APPROVED MINUTES

July 20, 2023 Standards Committee Meeting

RE: Minutes from the July 20, 2023 Standards Committee Meeting

C. STANDARD SPECIFICATIONS, SPECIAL PROVISIONS, AND STANDARD DRAWINGS PROPOSAL

E 801-TCCB-01 TEMPORARY CONCRETE BARRIER INDEX SHEET (WITH MARKUPS)

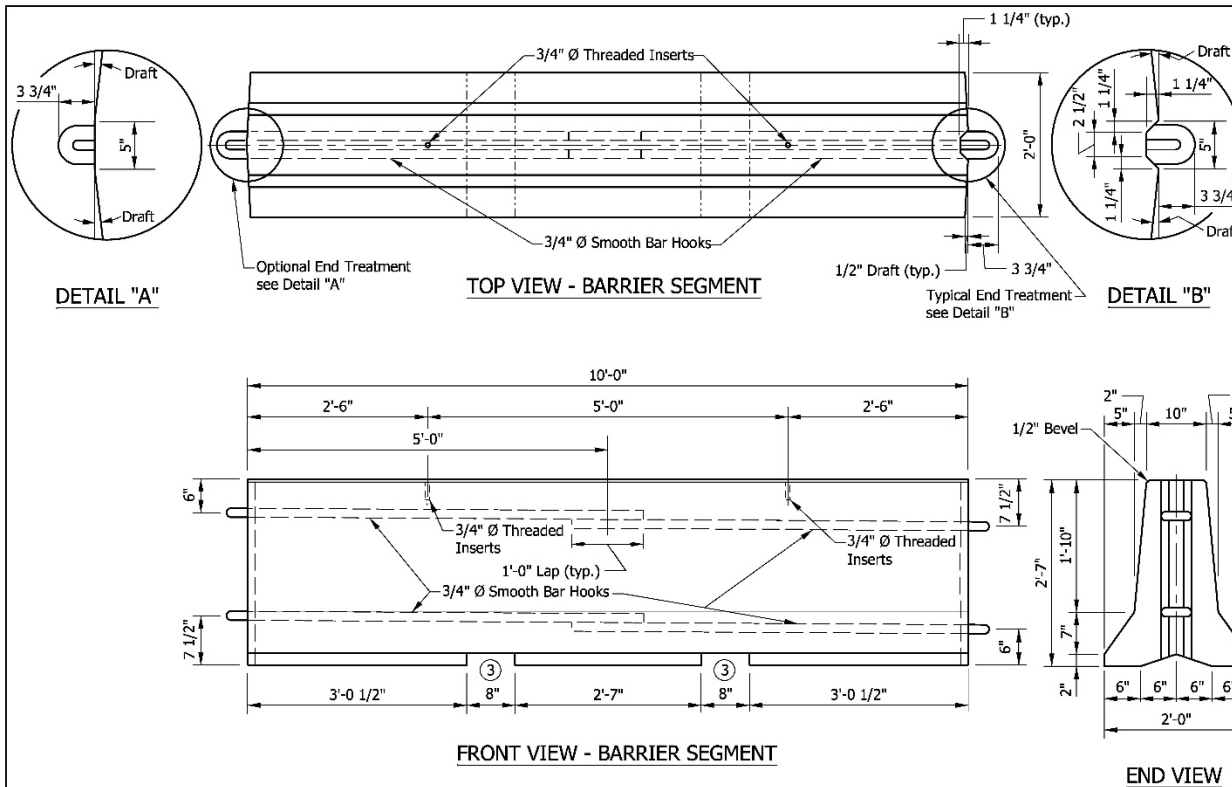
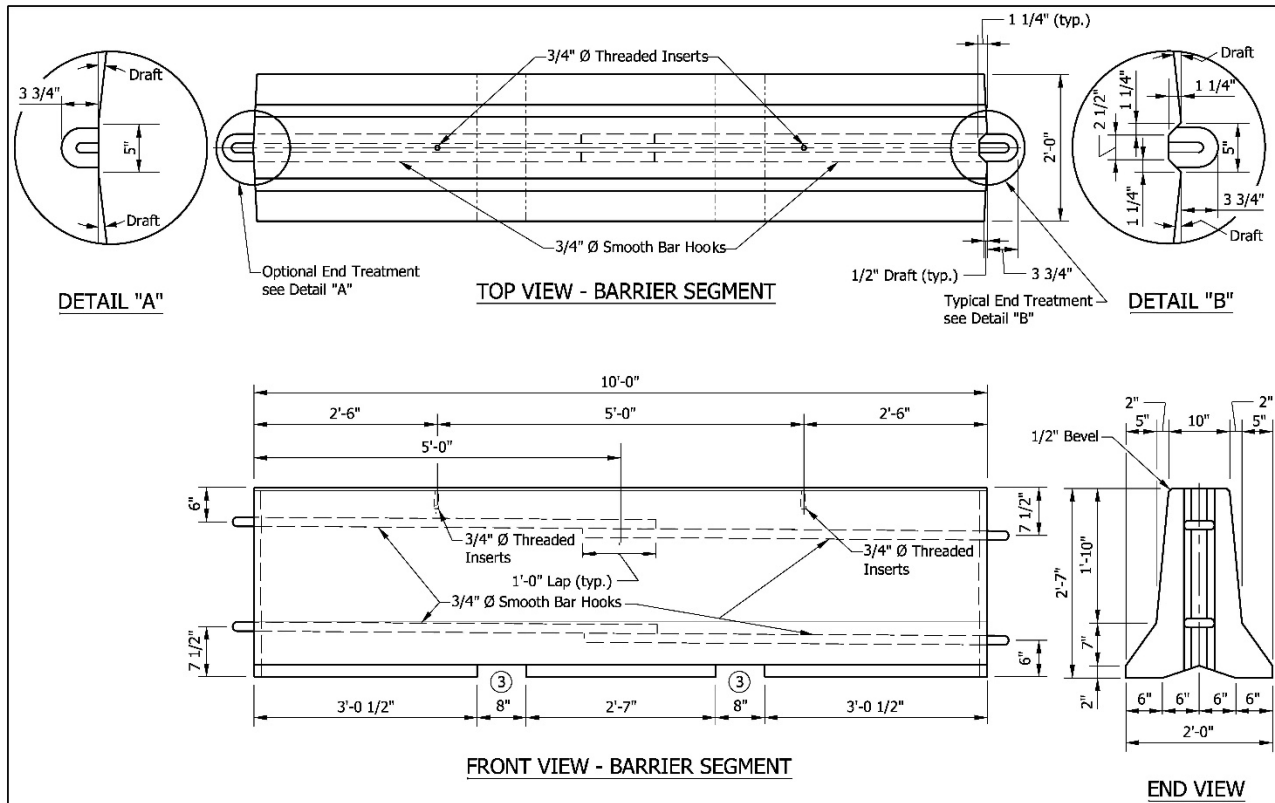
MARK-UP Editorial change to index this sheet

E 801-TCCB-02 TEMPORARY CONCRETE BARRIER DIMENSIONS (WITH REVISED MARKUPS)

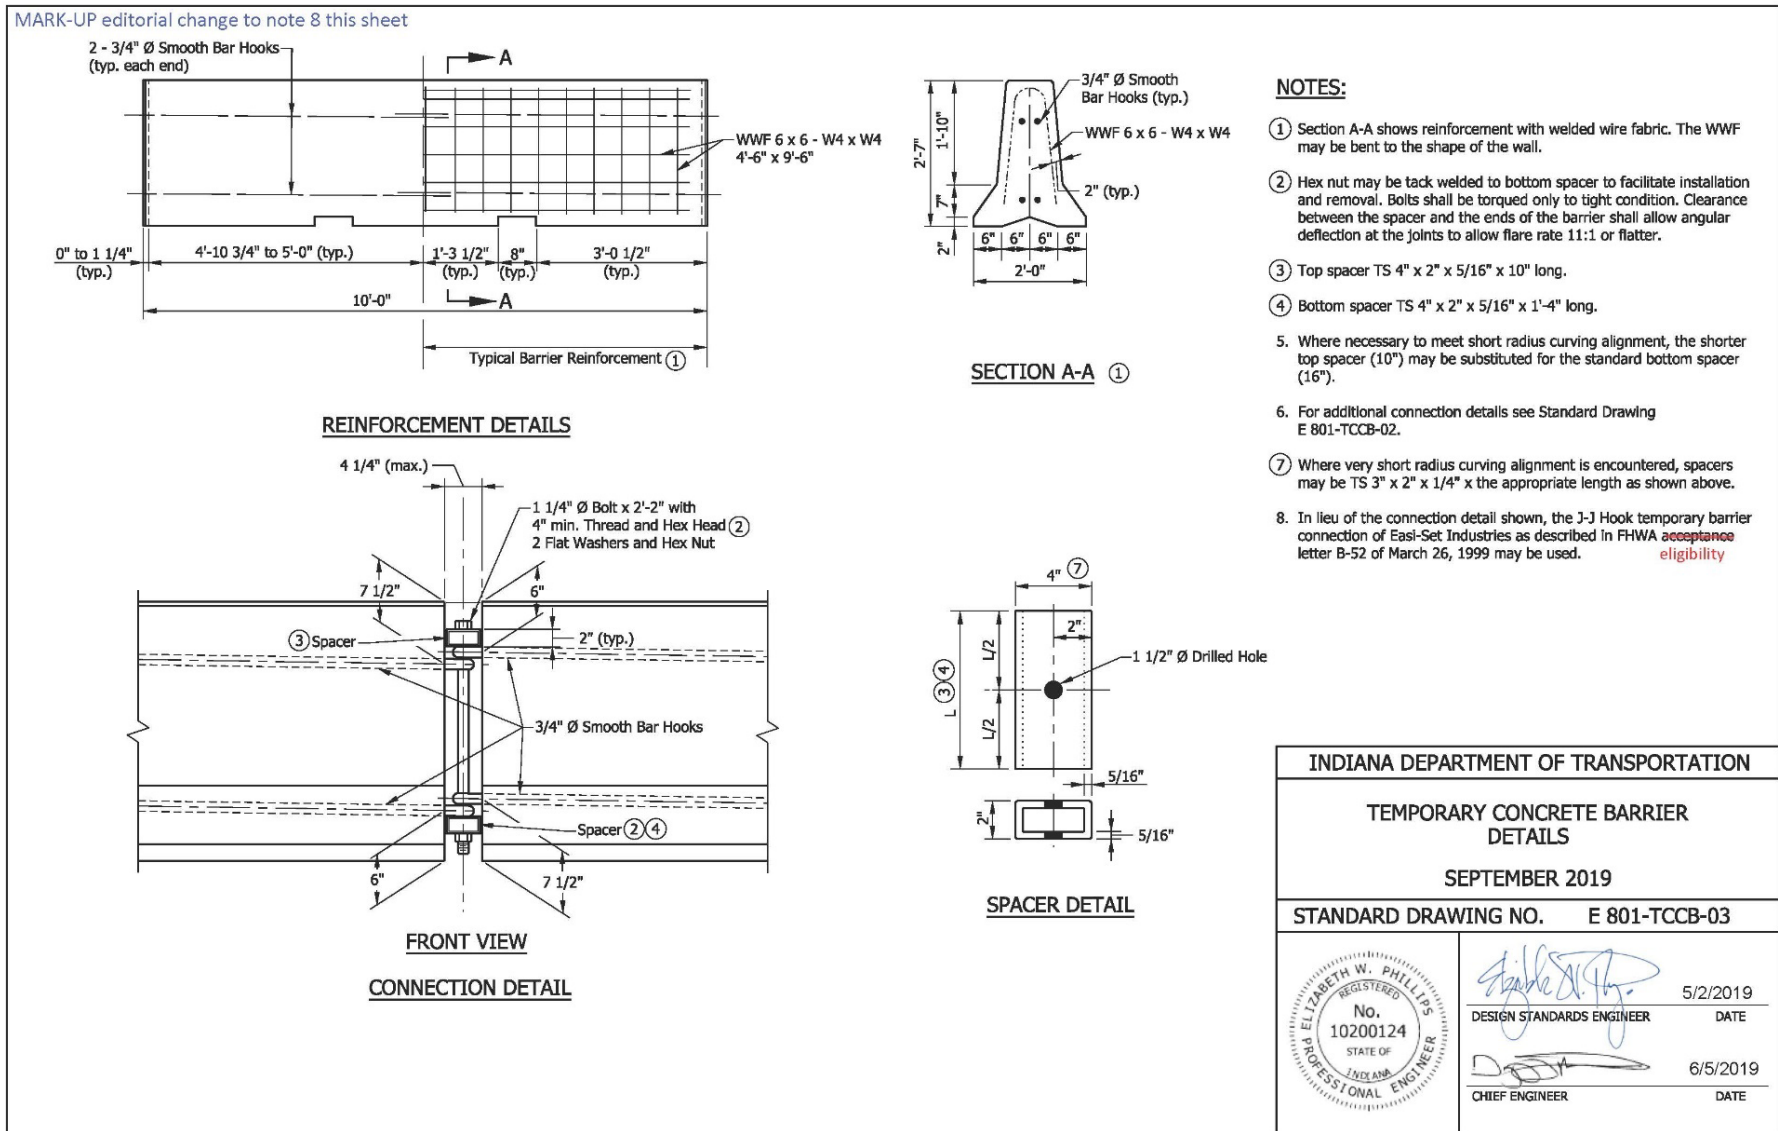
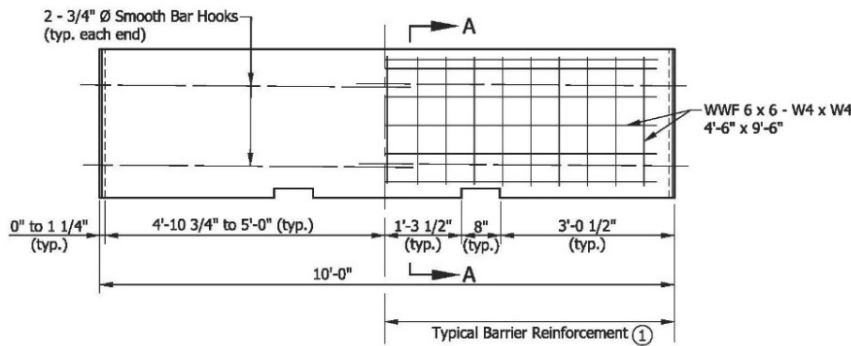
- 1 For freeways and interstates, the maximum barrier flare rate and construction clear zone distance shall be based on 70 mph for the first run of barrier within the construction zone. For subsequent barrier placement, the barrier flare rates and construction clear zone distance shall be based on 70 mph unless otherwise shown on the plans.
 The barrier taper flare rate
- 2 Maximum barrier taper rate flare and construction clear zone distance for construction zone speed are shown in Table No. 1. Construction clear zone distance is measured from the through travel lane.
 The barrier taper flare rate shall be as shown or flatter.
- 3 The dimensions of the lifting slots are subject to adjustment as necessary to accommodate handling equipment.
- 4 For additional connection details see Standard Drawing E 801-TCCB-03.

- 1 For freeways and interstates, the maximum barrier flare rate and construction clear zone distance shall be based on 70 mph for the first run of barrier within the construction zone. For subsequent barrier placement, the barrier flare rates and construction clear zone distance shall be based on 70 mph unless otherwise shown on the plans.
- 2 The barrier taper flare rate and construction clear zone distance are shown in Table No. 1. Construction clear zone distance is measured from the through travel lane. The barrier taper flare rate shall be as shown or flatter
- 3 The dimensions of the lifting slots are subject to adjustment as necessary to accommodate handling equipment.
- 4 For additional connection details see Standard Drawing E 801-TCCB-03.

E 801-TCCB-03 TEMPORARY CONCRETE BARRIER DETAILS (EDITORIAL CHANGE)

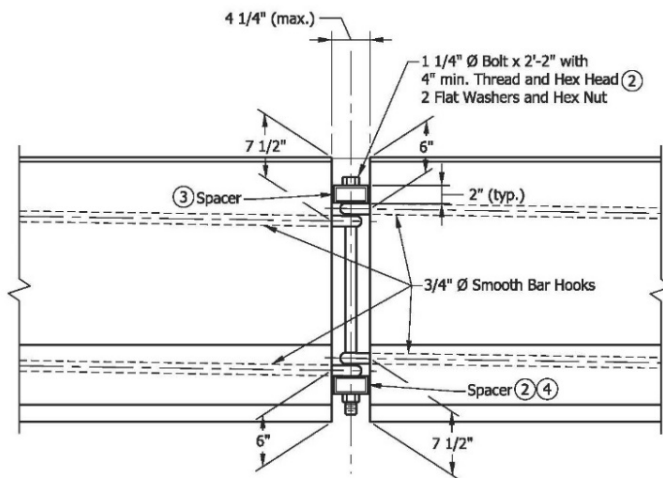
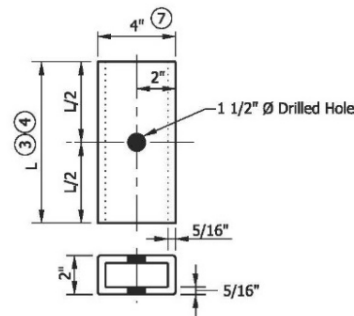
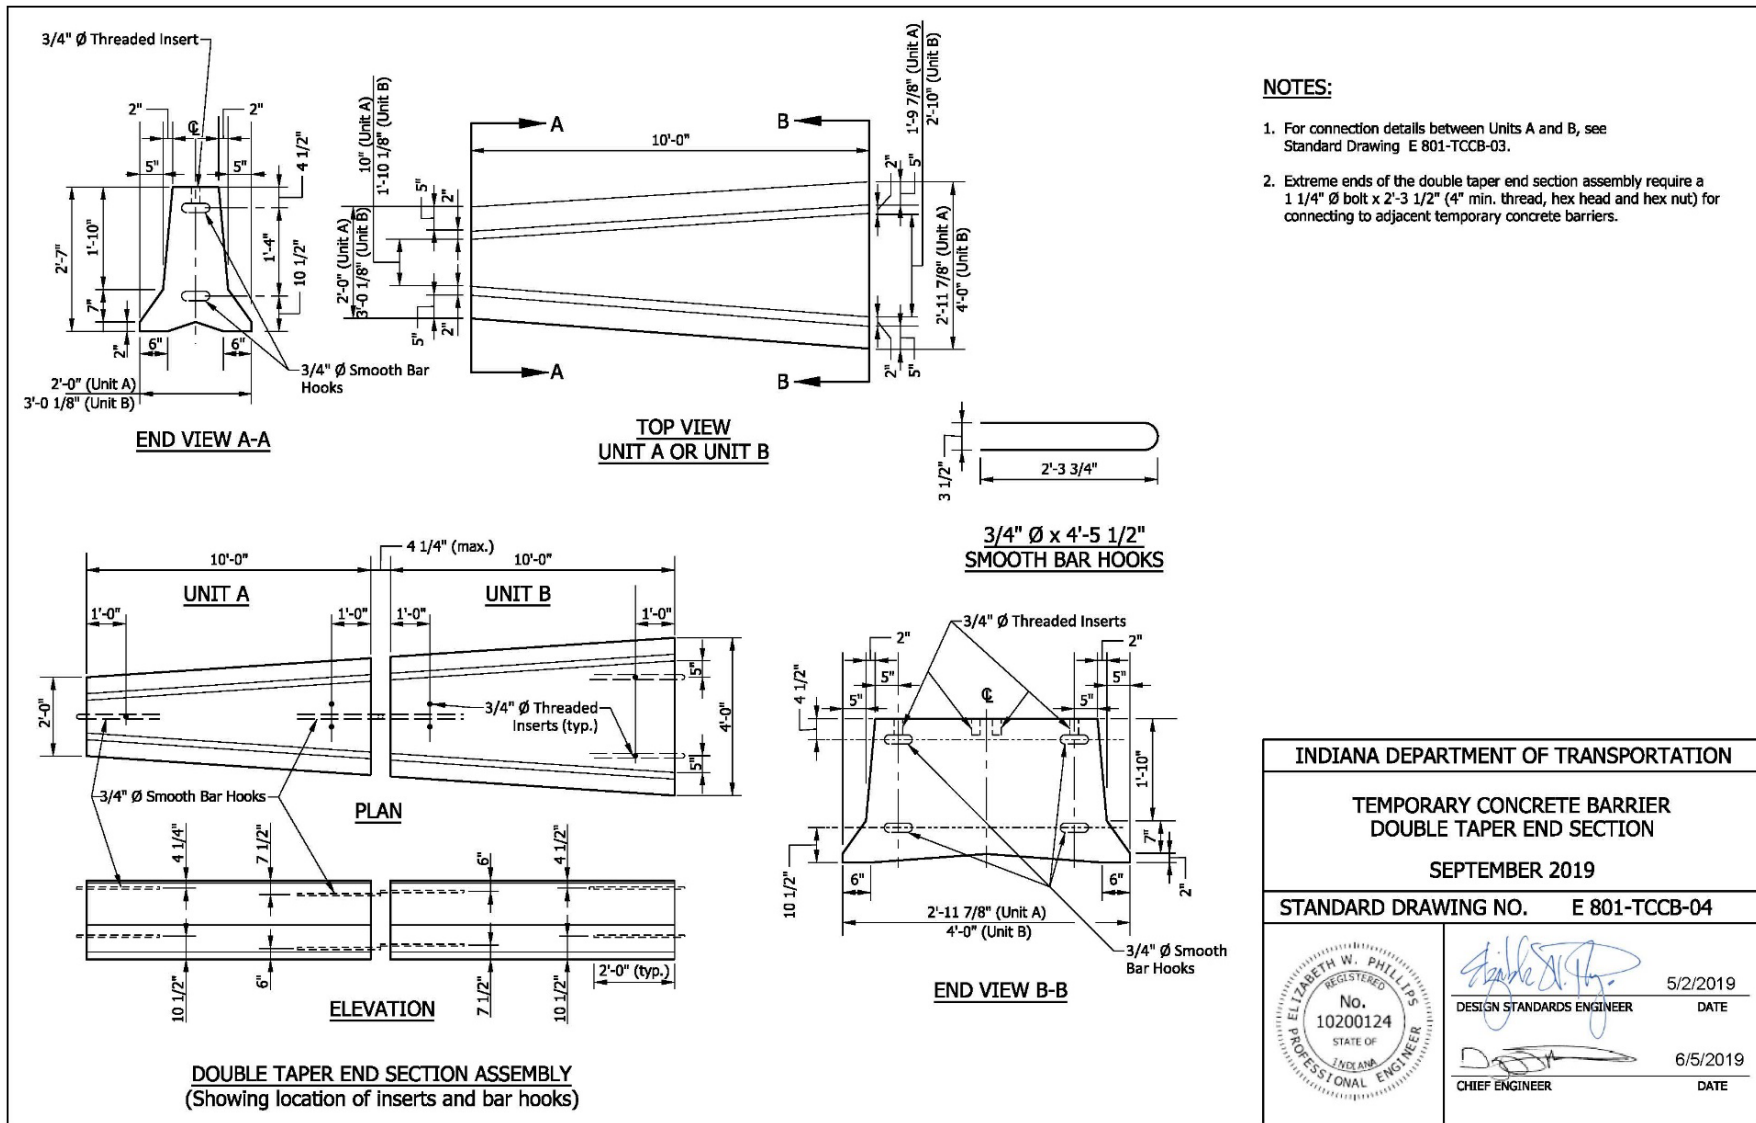
6. For additional connection details see Standard Drawing E 801-TCCB-02.
- ⑦ Where very short radius curving alignment is encountered, spacers may be TS 3" x 2" x 1/4" x the appropriate length as shown above.

1. TTB Flared with End Outside Construction Clear Zone

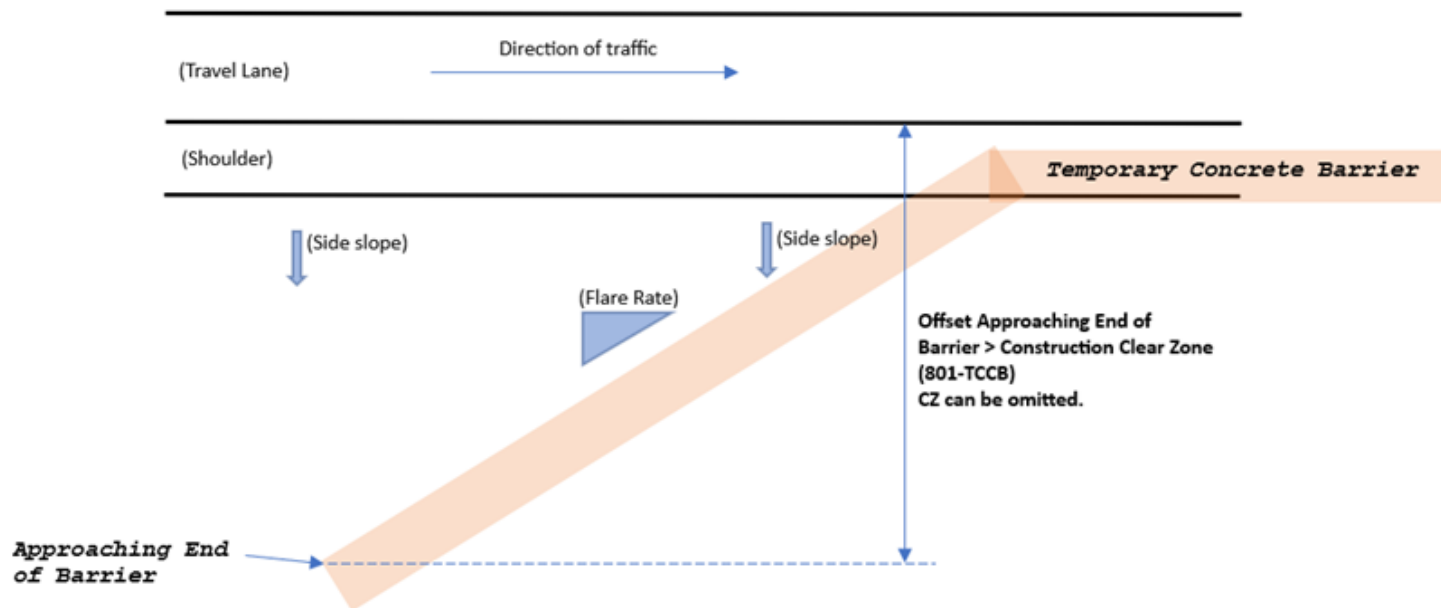
- (Freeway/Interstate) Side slope on approach and under barrier must be 10:1 or flatter. Other roadways 4:1 max**
- Barrier flare rate must be equal to or flatter than required based on Construction Zone Speed**

Proposed revisions for RSP 801-T-207 and Standard Drawing series 801-TCCB are as described in the proposal sheet and shown above. Ms. Mouser shared additional intended revisions to the drawings and GIFE changes.

2. TTB Parallel to Traffic with CZ

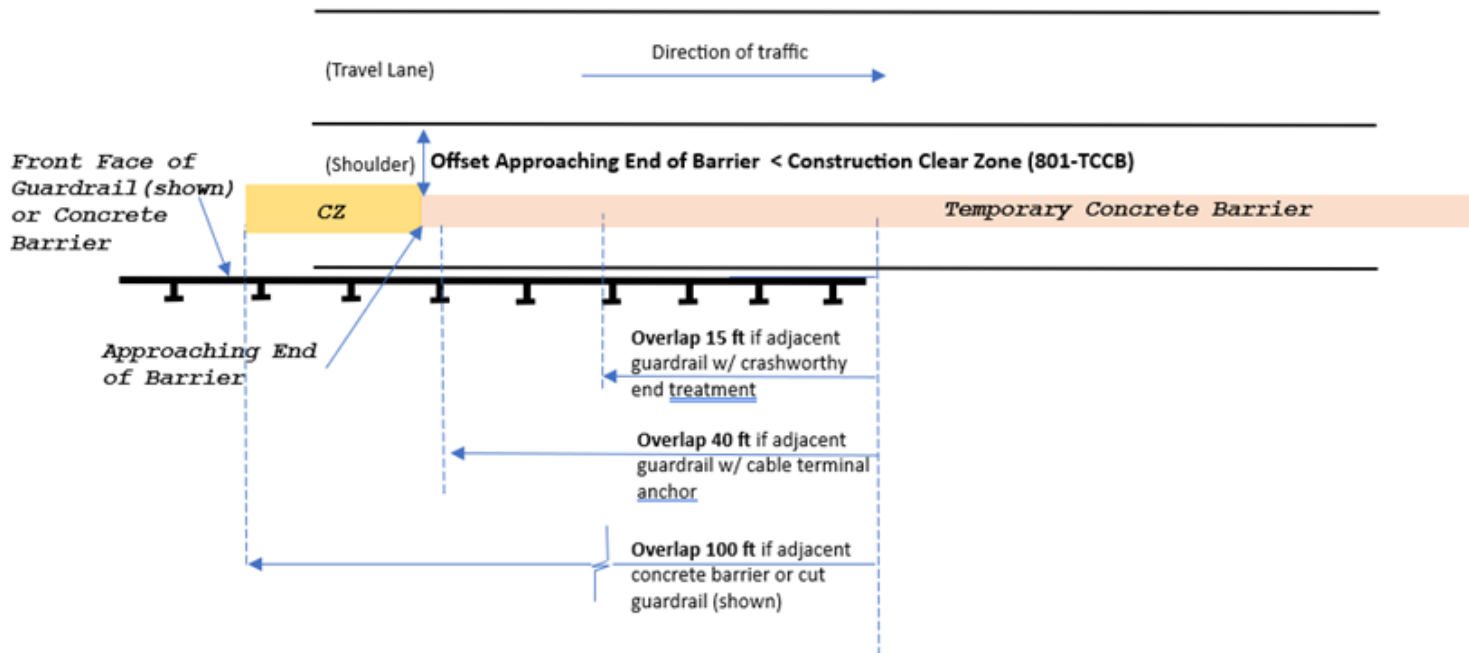
- Approach end of TTB must overlap guardrail or concrete barrier by required distance shown.**

E 609-BRJT-01 TYPE I-A JOINT (WITH MARKUPS)

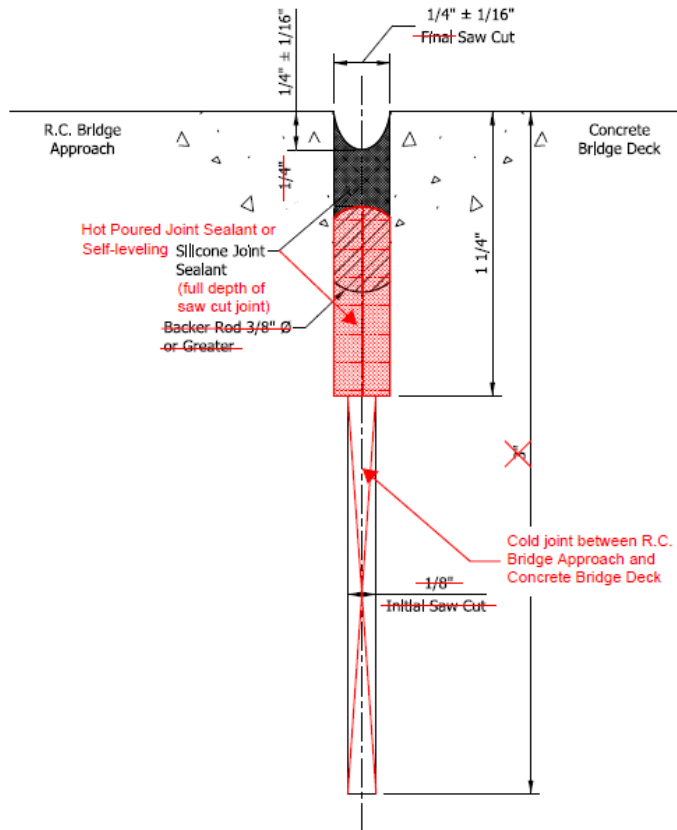
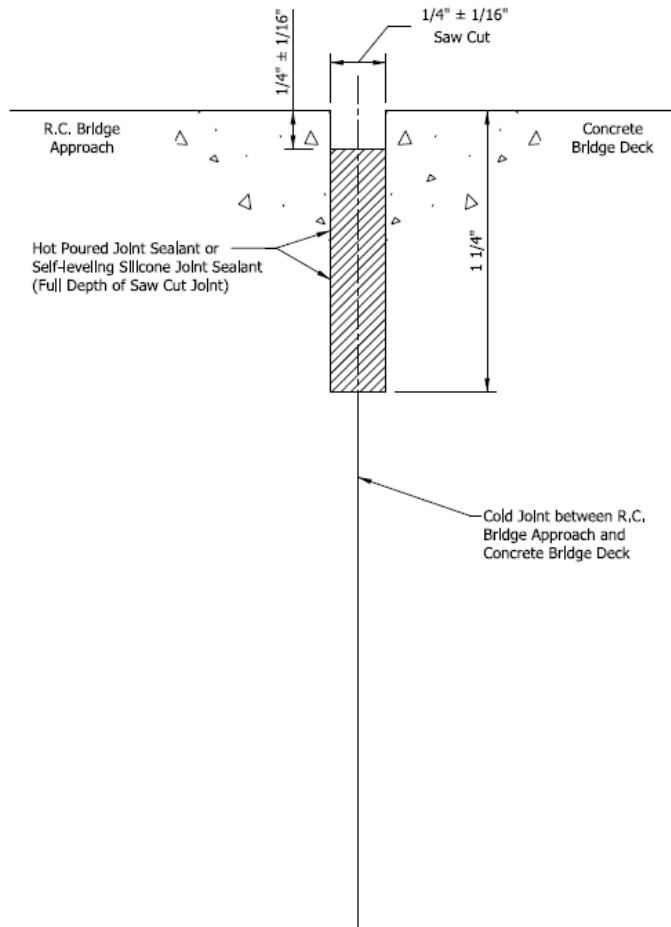
This item was introduced and presented by Mr. White who explained that the current detail for Type I-A joints includes a backer rod to limit the depth of silicone sealant to the upper 1/2 in. of the joint, leaving the remaining depth open. Research has shown that this creates a space for moisture to enter once the sealant breaks down, causing the space below the sealant to experience more rapid deterioration of the concrete. Further clarification was provided by Mr. Nelson.

Similar to the current joint details for concrete pavement shown in Standard Drawing series E 503-CCPJ, Mr. White proposed that the backer rod will be eliminated and the saw cut joint will be completely filled with either silicone or hot poured sealant. The Type I-A joint will also be revised to a single saw cut rather than the current two phase cut to facilitate the complete filling of the joint and simplify construction.

Mr. Koch said that ideally the standard should be updated to show only hot pour as that is the only viable method for new construction but leave silicone available in the material section potentially allowing the material via USP's for specific situations.

Mr. White revised his motion, which was seconded by Mr. Koch.
